Product Change Notice (PCN)

PCN Number: **PCN-0451088R-01**

Product(s) Affected: **PJ-040-SMT-TR**

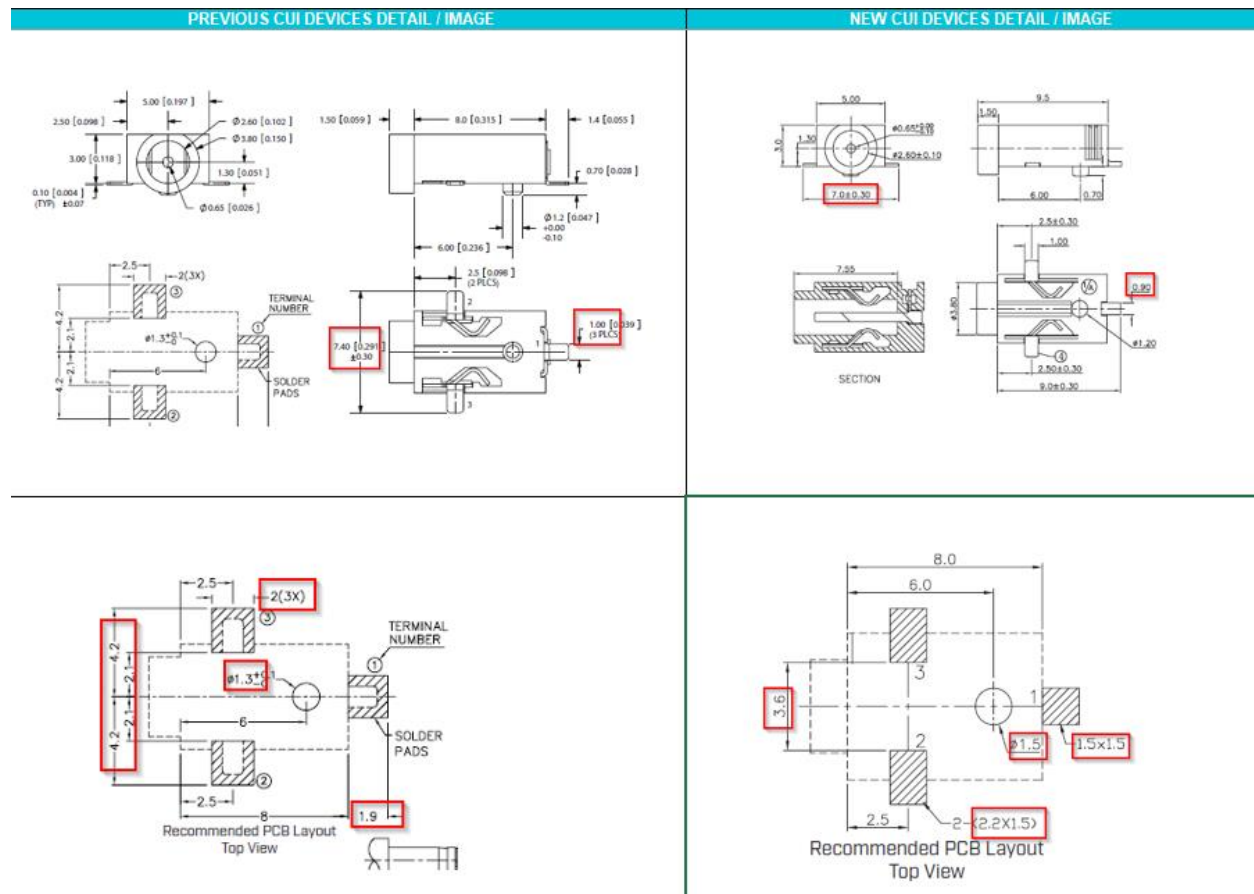
Description of Change: **Minor Housing and footprint differences. Material Change on the housing and terminals. See image Below**

PREVIOUS CUI DEVICES DETAIL / IMAGE	NEW CUI DEVICES DETAIL / IMAGE																																				
 <p>MATING PLUG Jack Insertion Depth: 7.7mm</p>	 <p>MATING PLUG Jack Insertion Depth: 7.55 mm</p>																																				
<table border="1"> <thead> <tr> <th></th> <th>MATERIAL</th> <th>PLATING</th> </tr> </thead> <tbody> <tr> <td>center pin</td> <td>copper</td> <td>nickel</td> </tr> <tr> <td>terminal 1</td> <td>brass</td> <td>silver</td> </tr> <tr> <td>terminal 2</td> <td>copper alloy</td> <td>silver</td> </tr> <tr> <td>terminal 3</td> <td>copper alloy</td> <td>silver</td> </tr> <tr> <td>plastic</td> <td>PA6T or equivalent</td> <td></td> </tr> </tbody> </table>		MATERIAL	PLATING	center pin	copper	nickel	terminal 1	brass	silver	terminal 2	copper alloy	silver	terminal 3	copper alloy	silver	plastic	PA6T or equivalent		<table border="1"> <thead> <tr> <th>DESCRIPTION</th> <th>MATERIAL</th> <th>PLATING/COLOR</th> </tr> </thead> <tbody> <tr> <td>center pin</td> <td>bronze</td> <td>silver</td> </tr> <tr> <td>terminal 1</td> <td>bronze</td> <td>silver</td> </tr> <tr> <td>terminal 2</td> <td>SUS301 t=0.20 mm</td> <td>gold</td> </tr> <tr> <td>terminal 3</td> <td>SUS301 t=0.20 mm</td> <td>gold</td> </tr> <tr> <td>housing</td> <td>PA10T (UL94V-0)</td> <td>black</td> </tr> </tbody> </table>	DESCRIPTION	MATERIAL	PLATING/COLOR	center pin	bronze	silver	terminal 1	bronze	silver	terminal 2	SUS301 t=0.20 mm	gold	terminal 3	SUS301 t=0.20 mm	gold	housing	PA10T (UL94V-0)	black

MATERIAL	PLATING																																			
center pin	copper	nickel																																			
terminal 1	brass	silver																																			
terminal 2	copper alloy	silver																																			
terminal 3	copper alloy	silver																																			
plastic	PA6T or equivalent																																				
DESCRIPTION	MATERIAL	PLATING/COLOR																																			
center pin	bronze	silver																																			
terminal 1	bronze	silver																																			
terminal 2	SUS301 t=0.20 mm	gold																																			
terminal 3	SUS301 t=0.20 mm	gold																																			
housing	PA10T (UL94V-0)	black
